Calculation/Analysis Change Notice

3. Document Identifier: 060-PSA-CR00-00200-000	4. Rev.: 00A	5. CACN: 001
6. Title: Canister Receipt and Closure Facility Reliability and Event Sequence Categorization Analysis		
7. Reason for Change: Condition Report 11923 indicates that Attachment H is missing a file. The purpose of this CACN is to supplement Attachment H with the missing file, whose name is "ITS EP for NSDB.zip". This file substantiates some controlling parameters and values reported in Table 6.9-1 of the calculation. This CACN does not change the method, results and conclusions of the calculation.

ATTACHMENT H SAPHIRE MODEL AND SUPPORTING FILES

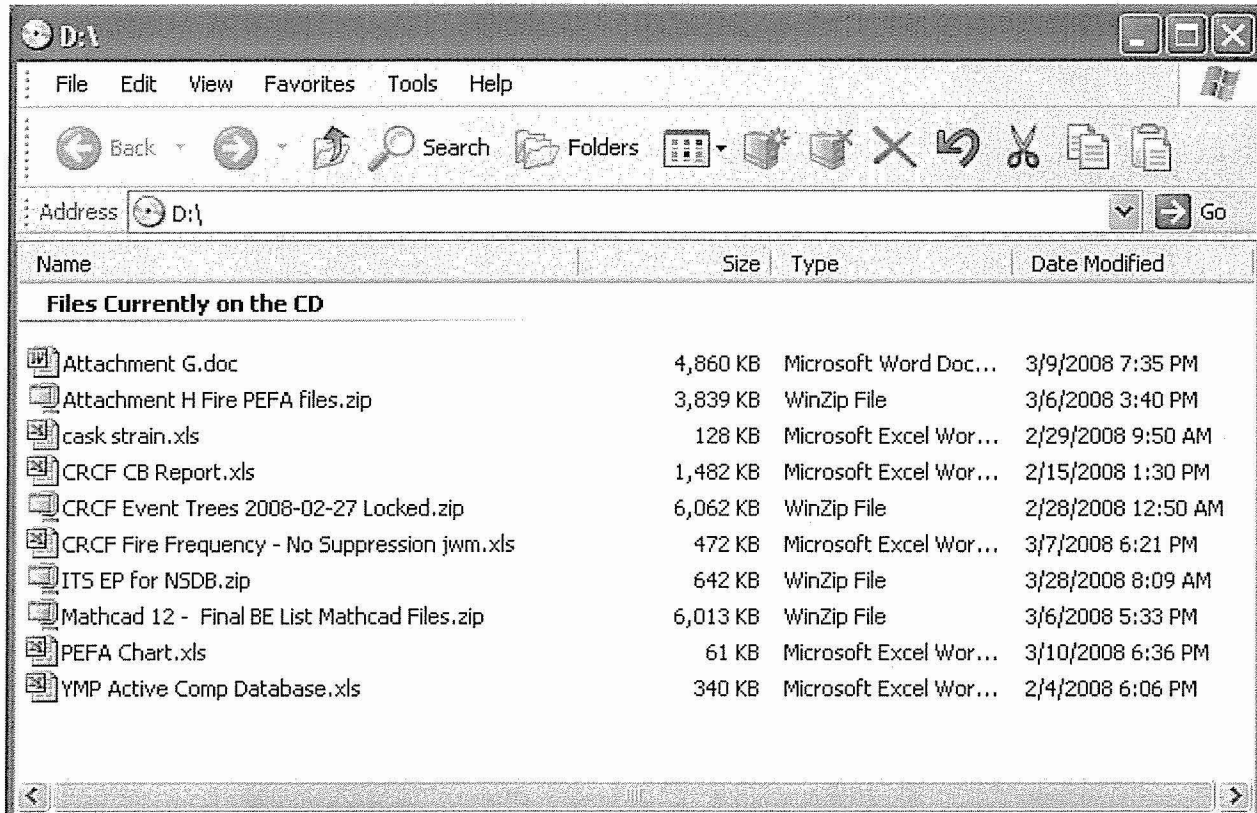
Affected page: H-2, replaced by the new page H-2 shown in page 2 of this CACN.
No added page.

Attachment H CD replaced by new attachment H CD.
